MBCA

November 16, 2018

Reference: Ord Mountain Solar and Energy Project Draft Environmental Impact Report (EIR)
October 2018 SCH No. 2017051082 Lead Agency: County of San Bernardino (County)

Exhibit 1: Proposed and Existing Solar Sites

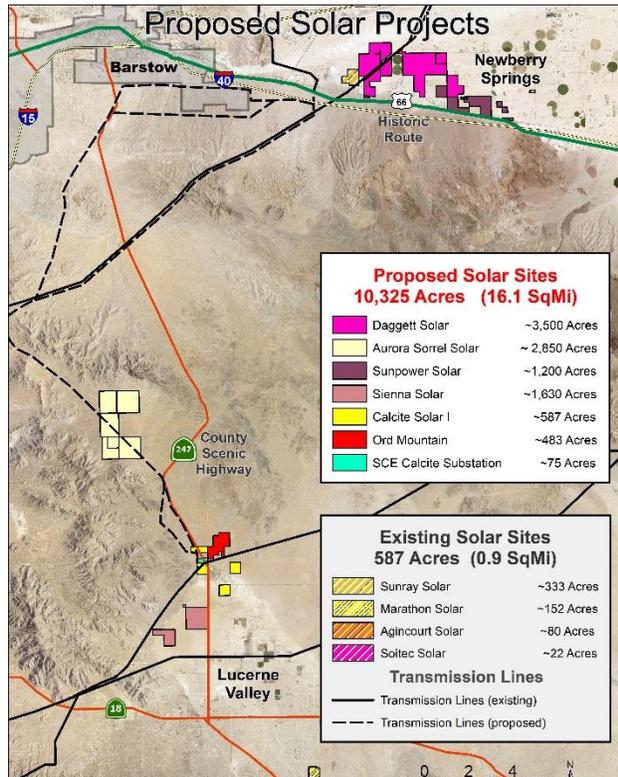
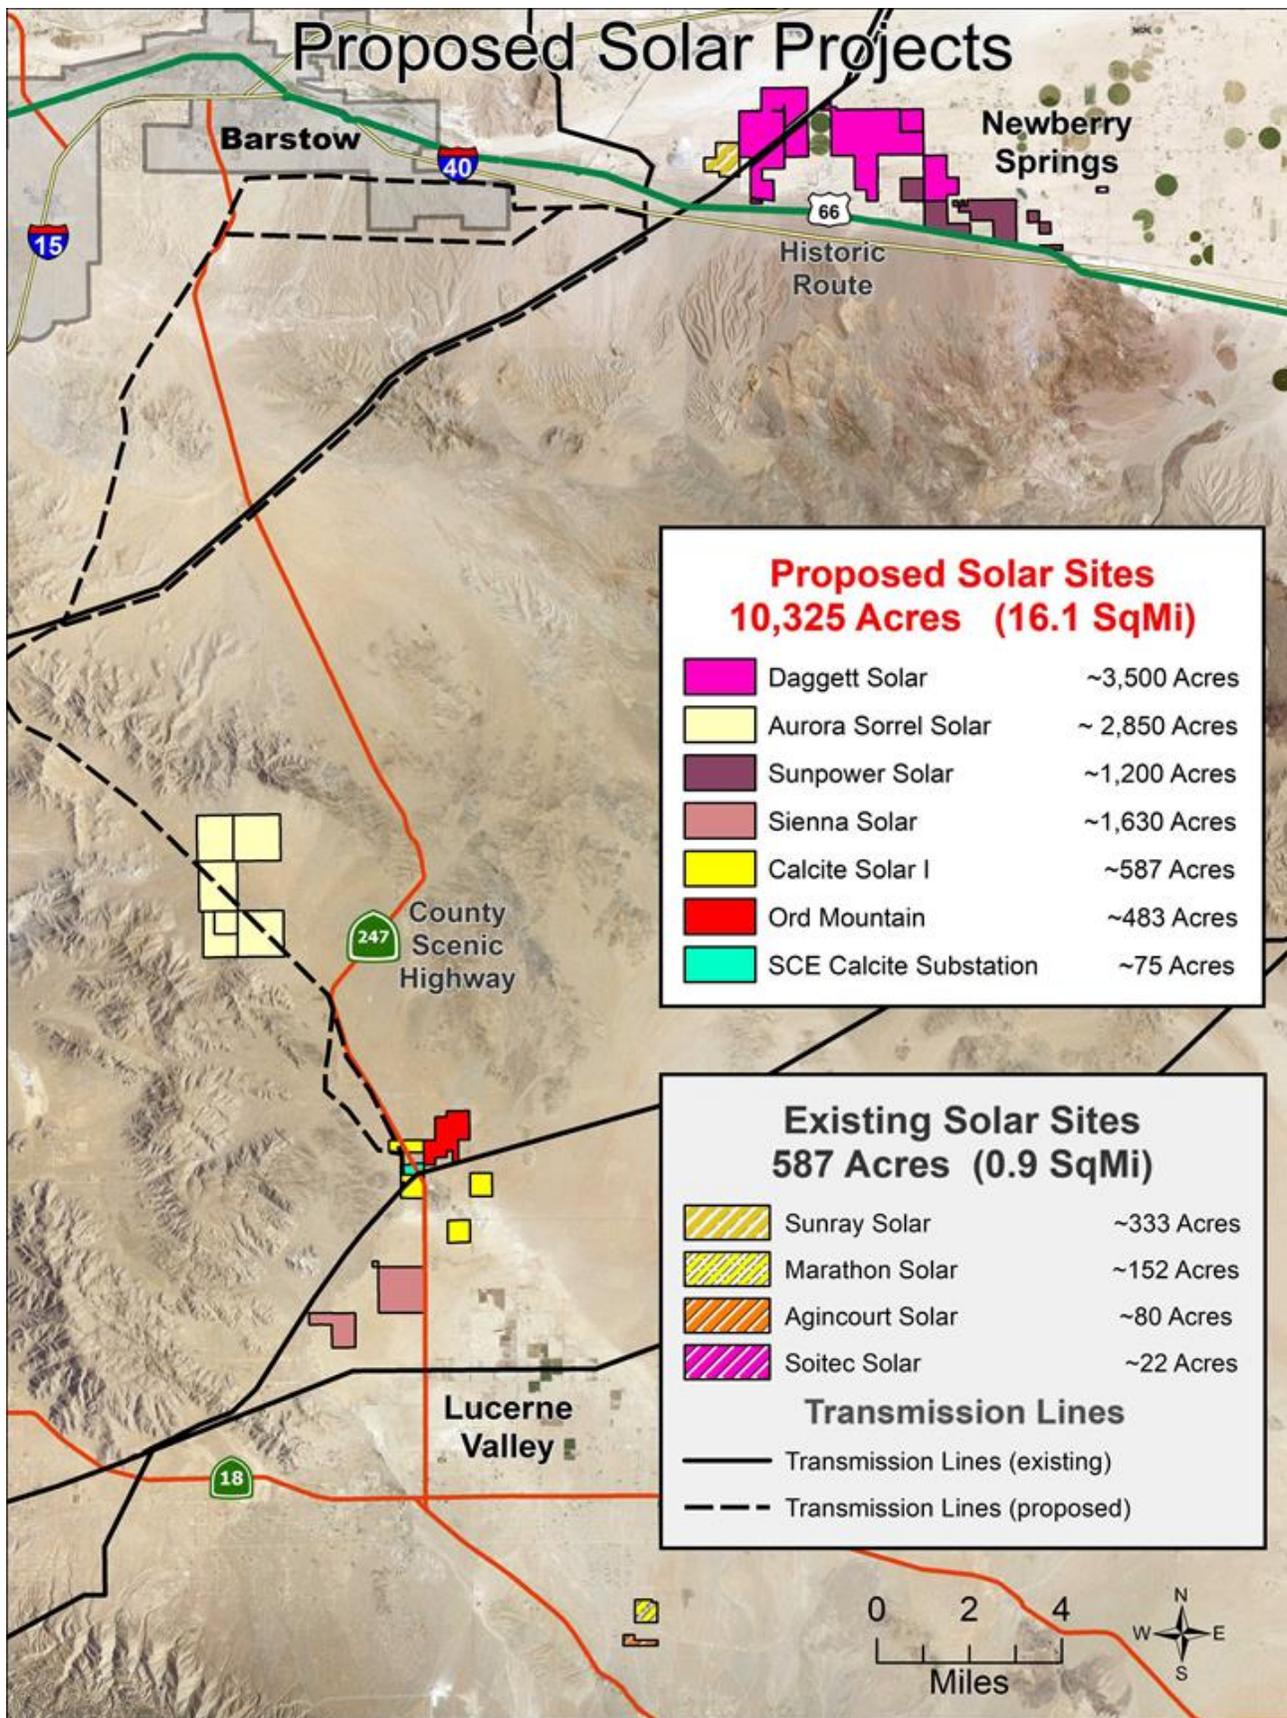
The cumulative effects of the Project include the effects of the all proposed solar projects in Lucerne Valley as well as the existing and proposed solar projects in Daggett and Newberry Springs, and all new transmission lines tied into to the planned Calcite Substation. We refer to this as the Cumulative Projects throughout this letter. The regional effects will be discussed under aesthetics, air quality, geology and soils, biological environment, and land use planning.

Lucerne Valley is burdened by over 5,000 acres of utility scale solar projects being planned for their community.¹³ The Mojave River Valley communities are also burdened from over 5000 acres of planned utility-solar in the heart of their planning areas. See Exhibit 1, this letter.

Exhibit 4: Homes within one-half mile of the Proposed Site

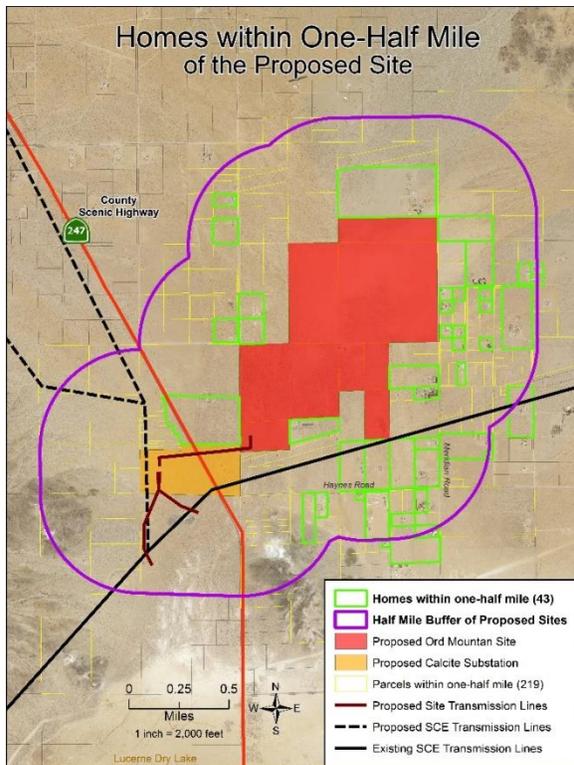
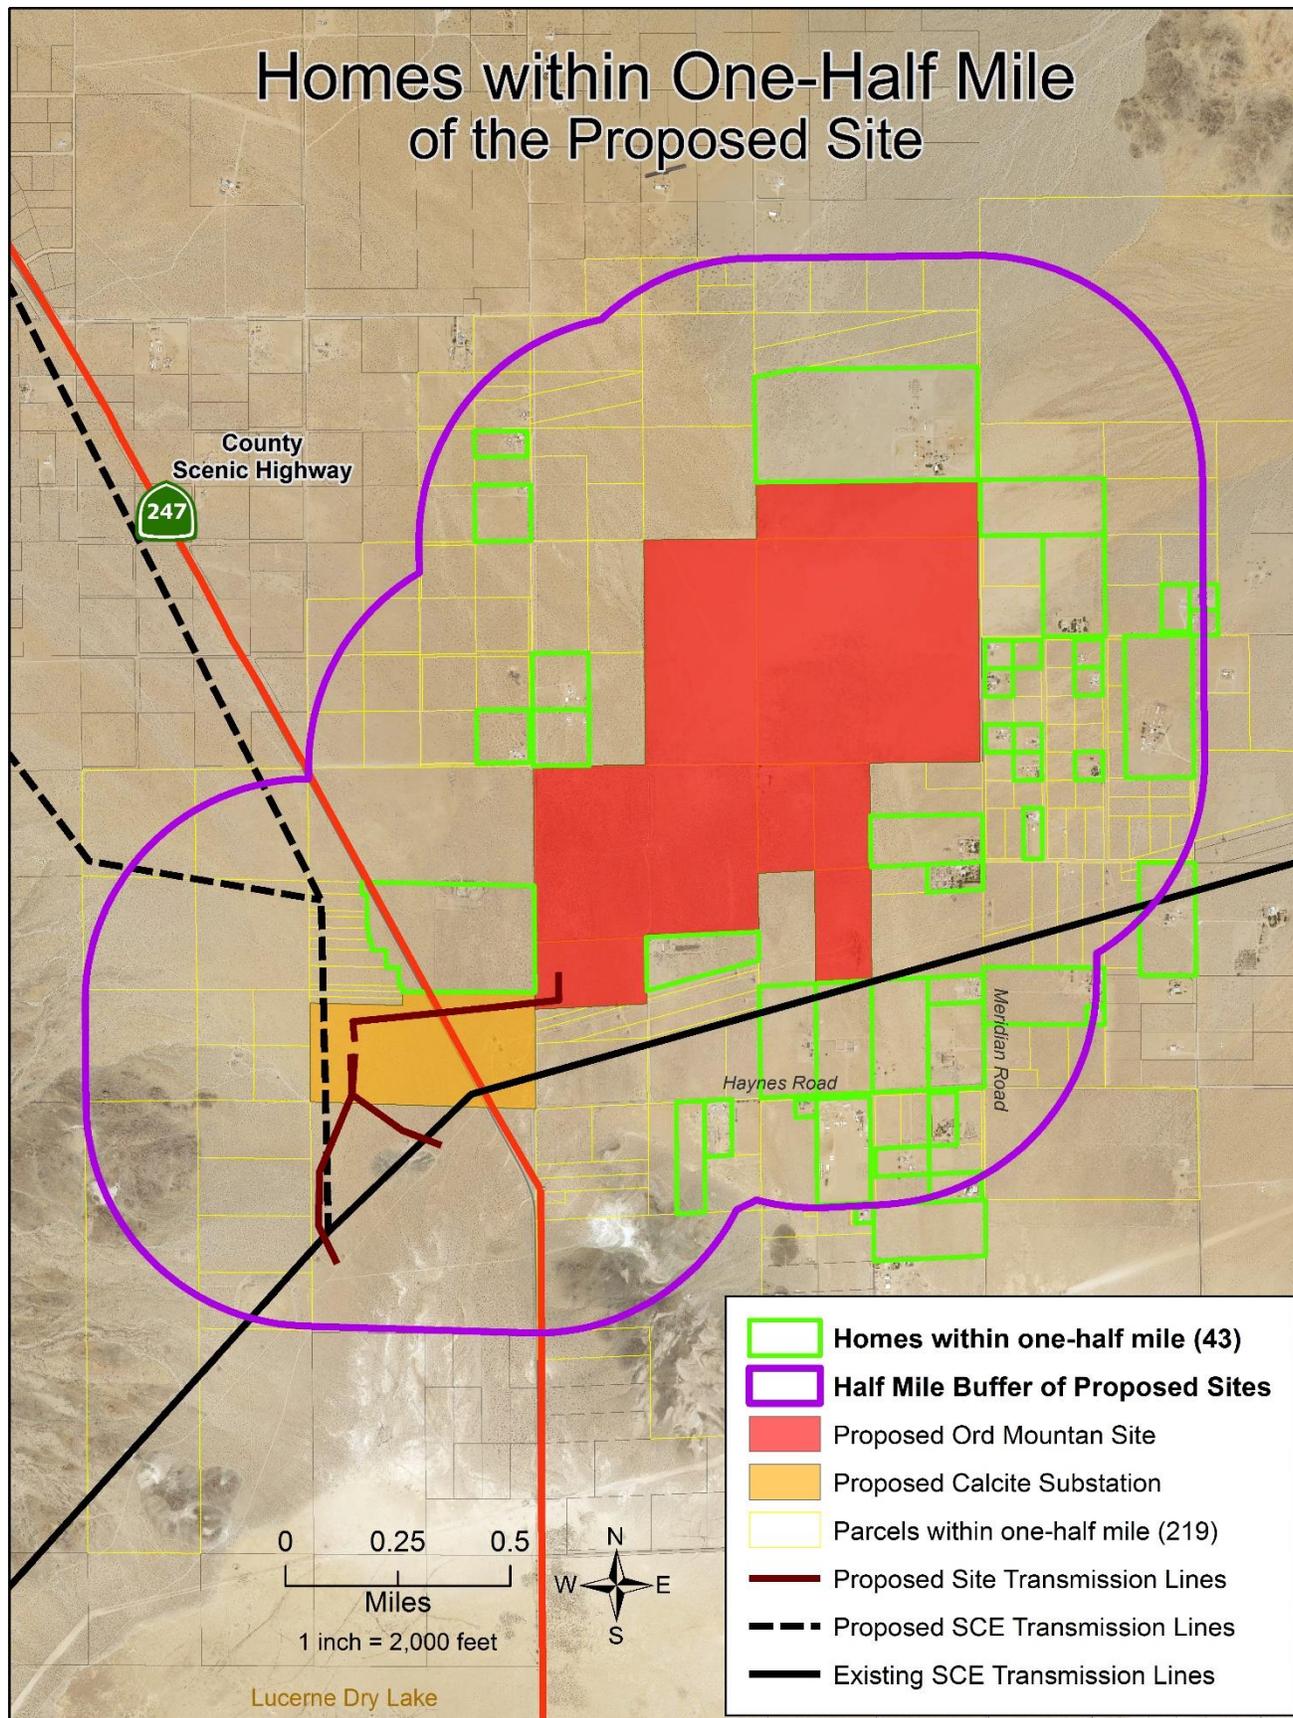
“Given the existing primarily undeveloped nature of the project area and the presence of flat, low-shrub-dotted terrain that affords residents open and unencumbered views of the surrounding mountainous terrain, residents will be highly aware of and sensitive to changes occurring in the visual landscape.” (EIR page 3.1-19)
There are 43 homes within a ½ mile radius of the Project. We are told that CEQA does not consider private views an aesthetic impact.

However, SR-247 is a County Scenic Highway¹² and according to Section 263.1 of the California Streets and Highways Code, the entire length of SR 247 is included in the State Scenic Highway System. LUS staff and residents are currently working with California toward its State Scenic Highway designation. Can the County knowingly destroy the scenic values of SR-247 without penalty? This is a CEQA matter. Is this a State Regulatory matter?

Exhibit 5: Visual Impacts of the Proposed Ord Mountain Solar Project

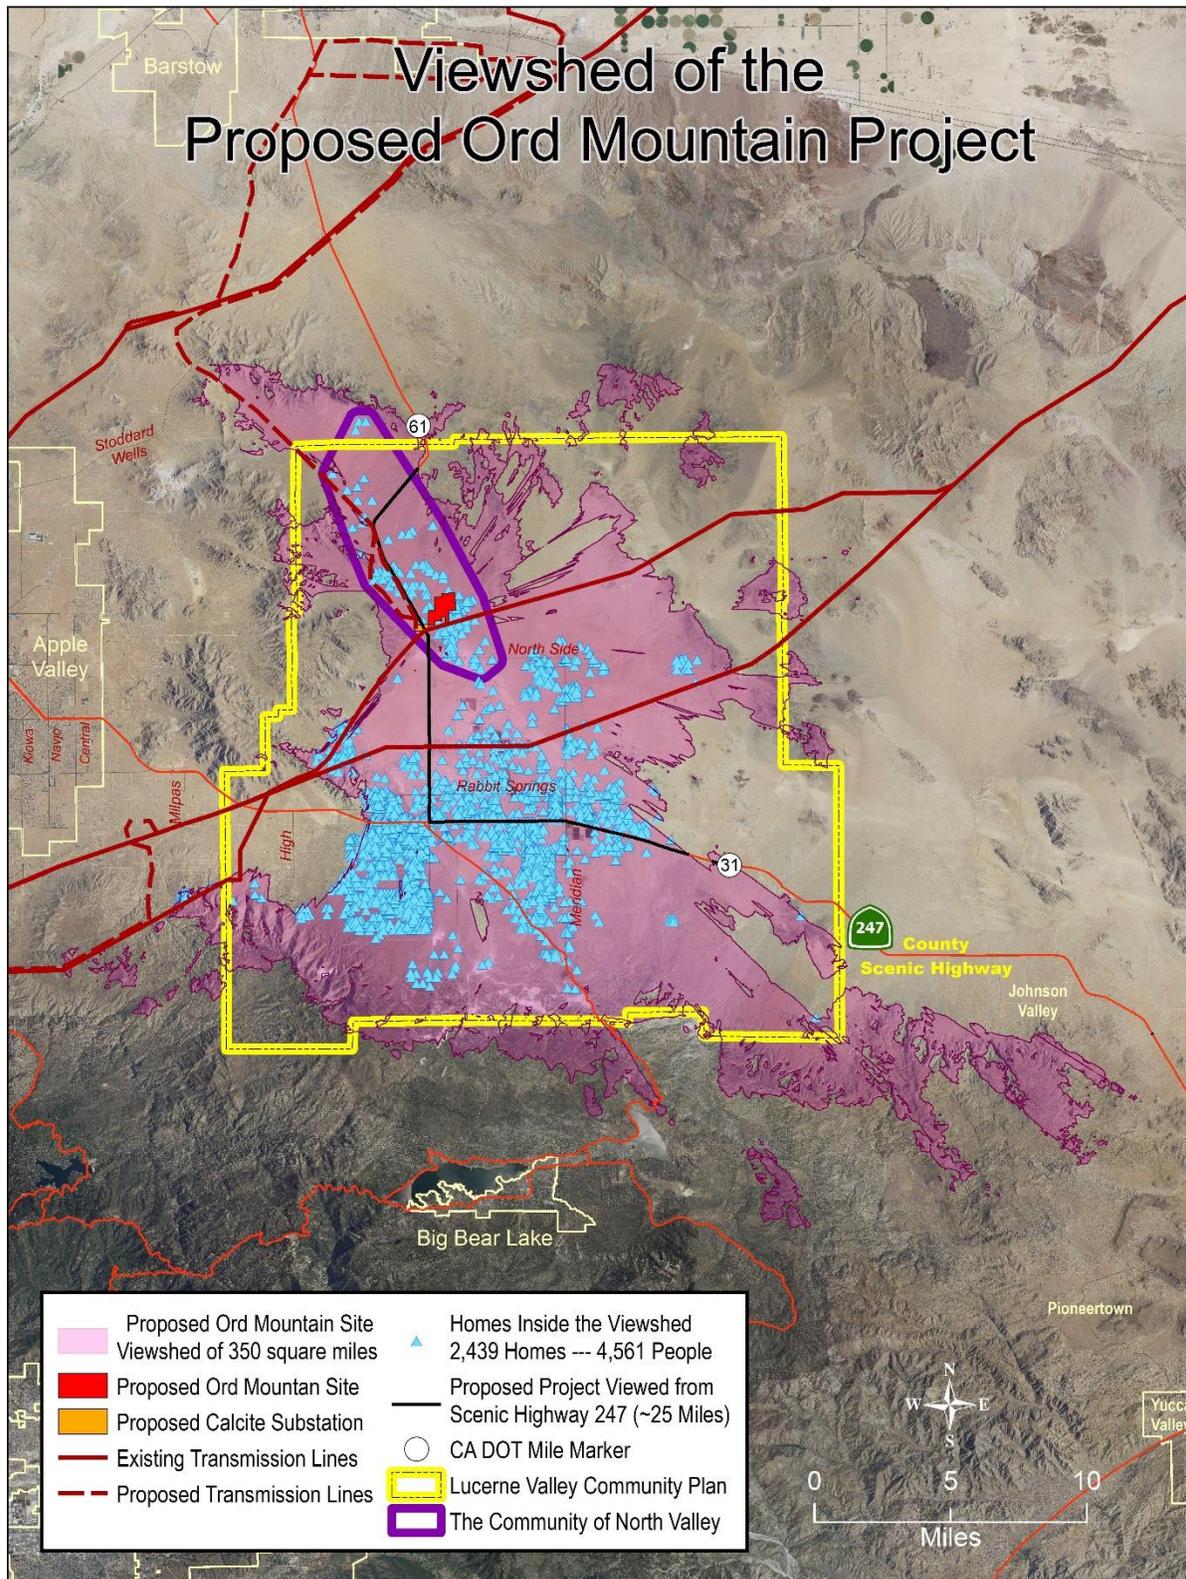
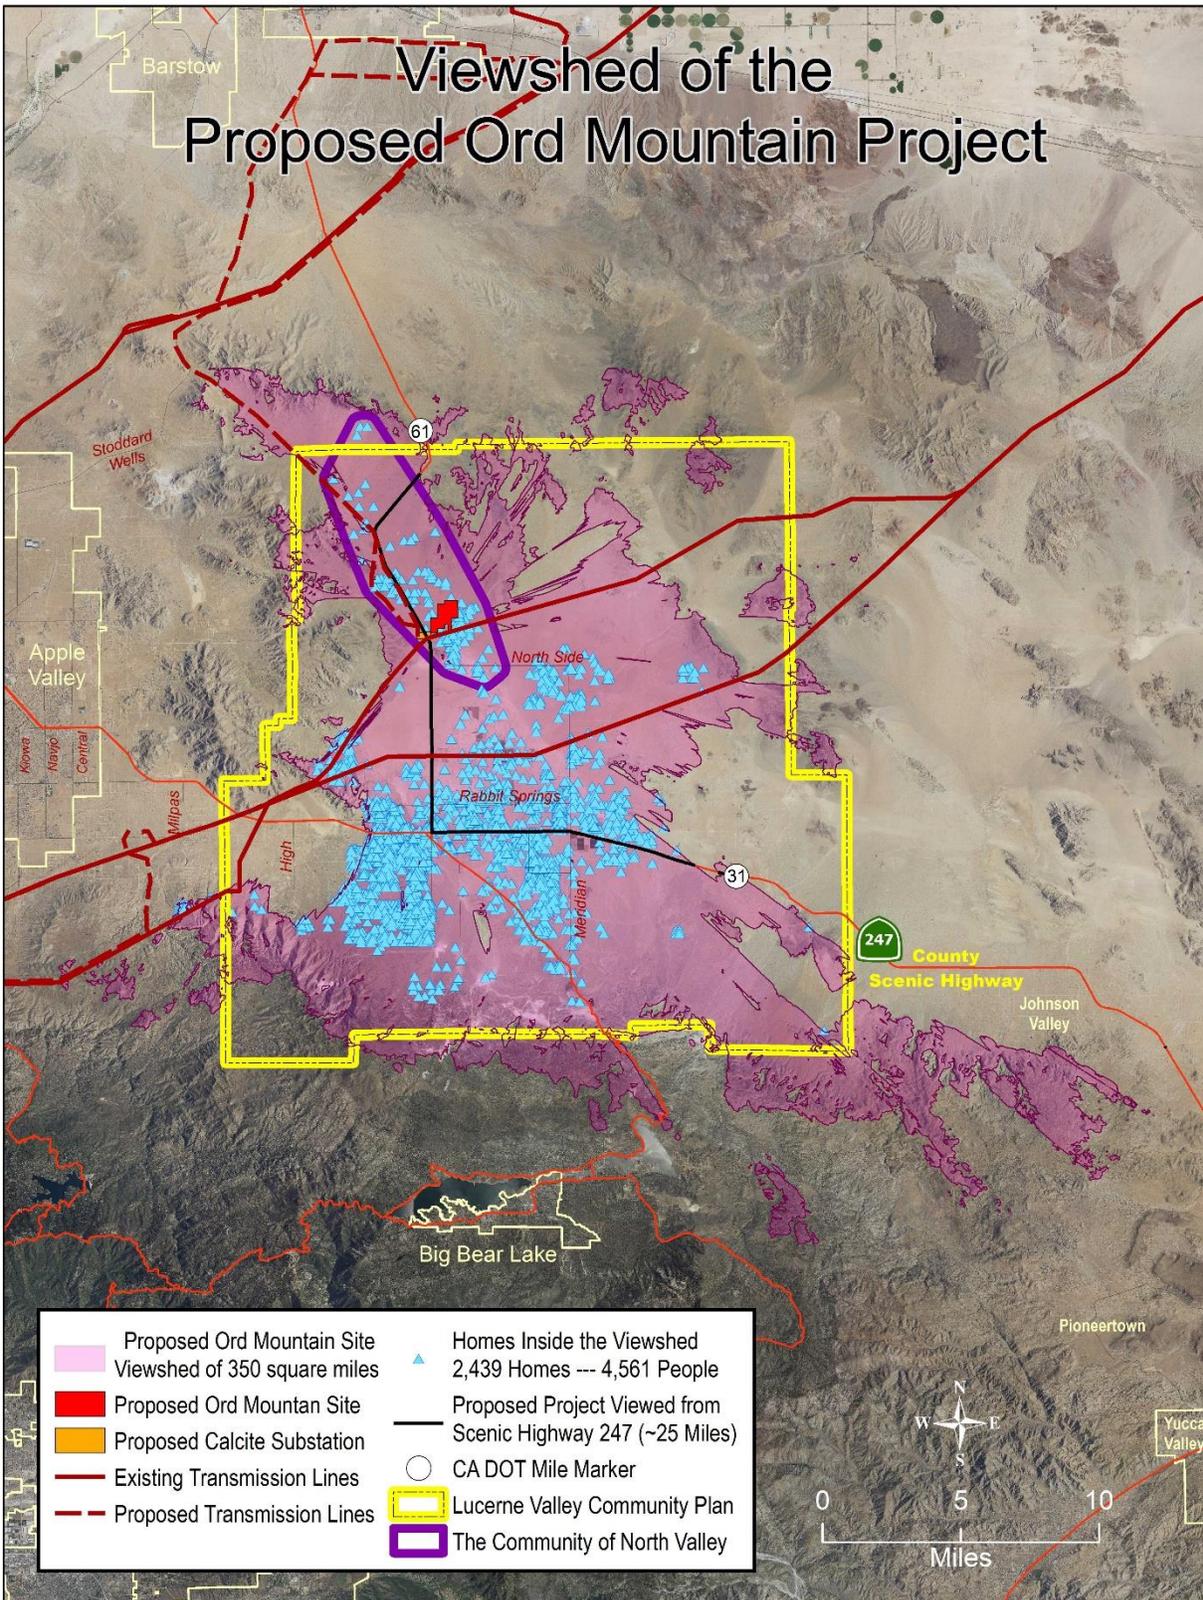
Comments from Brian Hammer, the creator of the viewshed exhibits 5 and 6, which are far different from that shown in the EIR Figure 3.1-4 Topographic Viewshed Analysis. The figures in this response reflect an accurate method of calculation. The essential methodology used includes an observer height based on the standing height of an average US male (with allowance for eye-level) and the proposed project structure heights as indicated in pages 2-18 and 2-20 and figures 2-3 and 2-5 of the Draft EIR.¹⁴

The impacts of the proposed Ord Mountain Solar and Calcite substation projects (Exhibit 5) on the viewshed would be overwhelming. At the most distant vantage points to the southeast the proposed projects would be visible for over thirty miles. The total area of visibility is over 350 square miles impacting the view of over 2,400 homes and the 4,500+ people that live there². The proposed projects would be visible to 87% of the residential homes of Lucerne Valley (CSA 29) and 100% of the residential homes of North Valley. The proposed projects would be visible for 25 miles of County Scenic Highway 247. The effects would be from approximately mile marker 33 to mile marker 61. This comprises over 30% of the Scenic Highways entire length.

- Calculated visibility of proposed projects to Scenic Highway 247 is 24.83 miles (planimetric)
- The proposed projects will be visible from Scenic Highway 247 from ~ Mile marker 33 to ~ Mile marker 61
- Proposed projects will be visible from 32% of the Scenic Highway 247
- Cumulative calculated visibility of proposed projects from Historic Route 66 is 32.41 miles (planimetric)
- Cumulative visibility of proposed projects from Interstate 40 is 34.65 miles (planimetric)
